Amendments to the Drawings:

REMARKS

Fig. 3

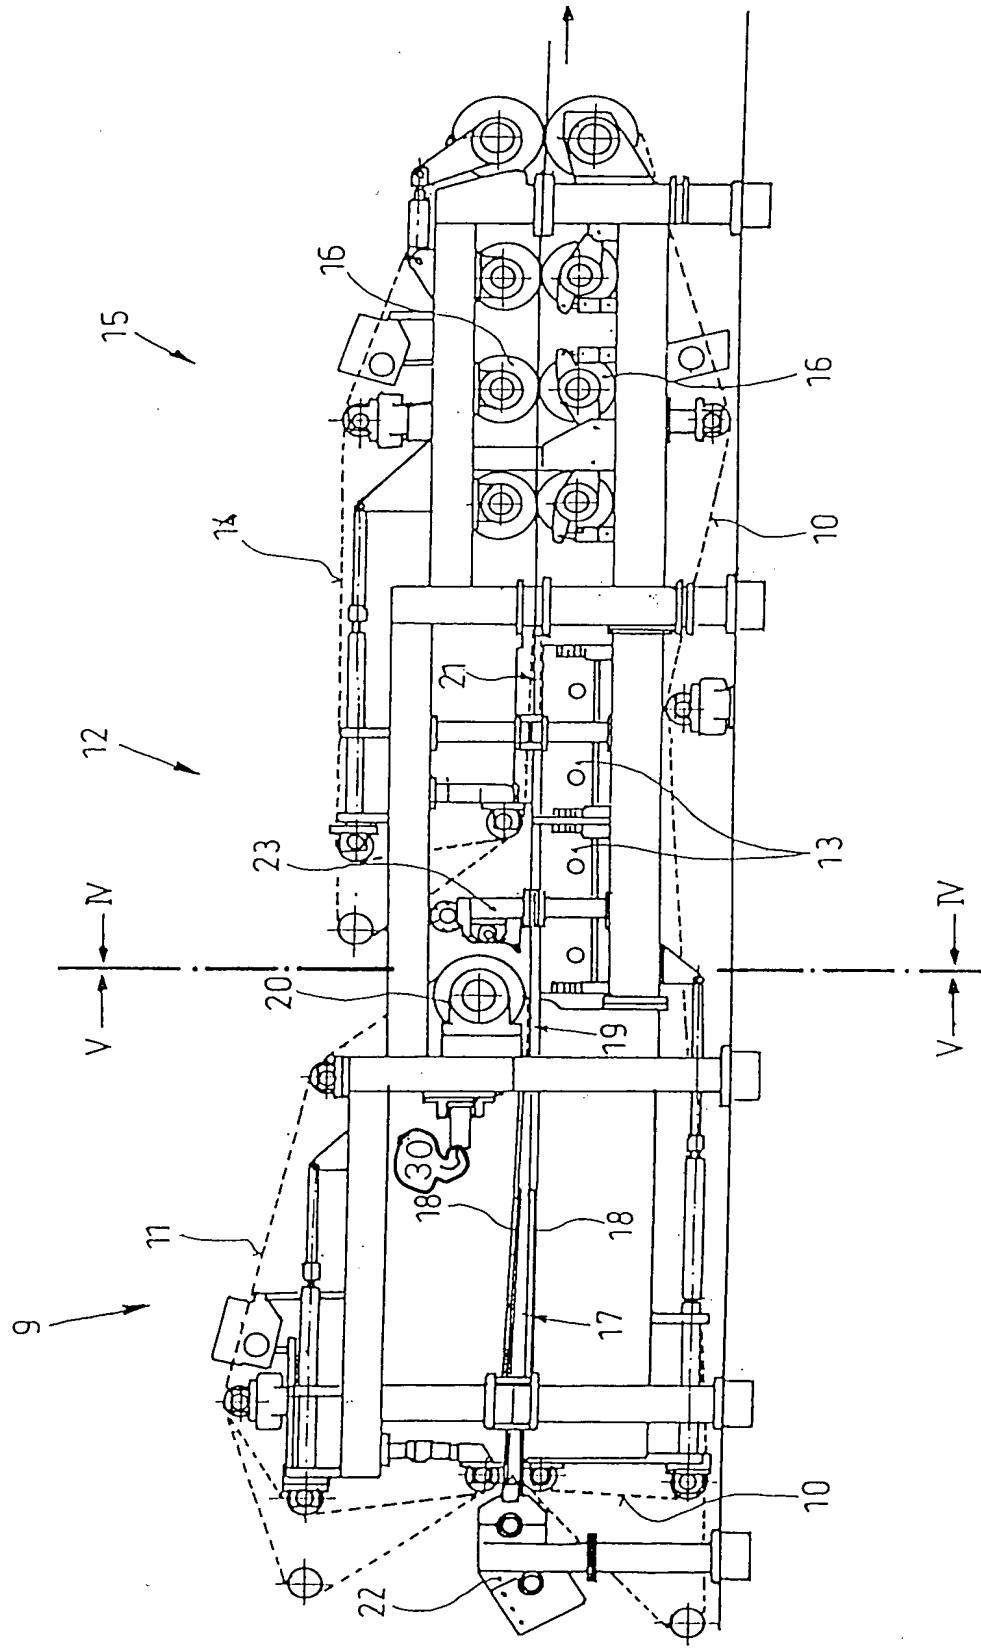
The attached sheet of drawings includes changes to Figure 3. This sheets, which includes Figure 3, replaces the original sheet including Figure 3.

In the interest of obtaining allowance, claim 1 has been amended to recite that the device includes "apparatus for pressure loading the outlet end of the first wedge zone." Figure 3 has been amended to include reference numeral 30 and a lead line from such reference numeral to the apparatus for pressure loading the first wedge zone outlet end. The specification has been amended to recite that "wedge zone 17 can be pressure loaded by the pressure loading apparatus 30." Since the apparatus has always been shown in Figure 3, these amendments do not constitute new matter.
